Access Compliance Report Public Rights-of-Way (RR Crossings)

Intersection ID: 50272	Main Street: SOUTH_BV	Location: N/A
ADA ID: 2FF826FB54BC	Overall Compliance: No	Severity Score: 0.0
Codes/Mitigation Info/Possible Solution		Field Measurements/Component Compliance

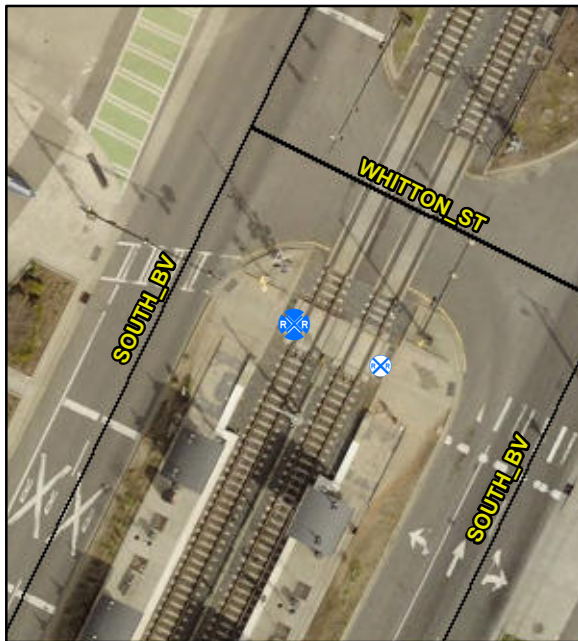
Remove & Replace Detectable Warning System. Provide Pedestrian Gate. Remove & Replace Walking Surface Adjacent to Rail.

R302.7.4, R305.2.5

Compliance	Description	Data
Yes	DWS Provided?	Yes
Yes	DWS Contrast?	Yes
Yes	DWS Width (in)	Yes
Yes	DWS Length (in)	24.0
No	DWS Offset (in)	15.0
No	Pedestrian Gate?	No
N/A	DWS Outside Gate?	N/A
N/A	Rail Type?	LightRail
No	Flangeway Gap (in)	3.0
Yes	Sidewalk Width (in)	107.0
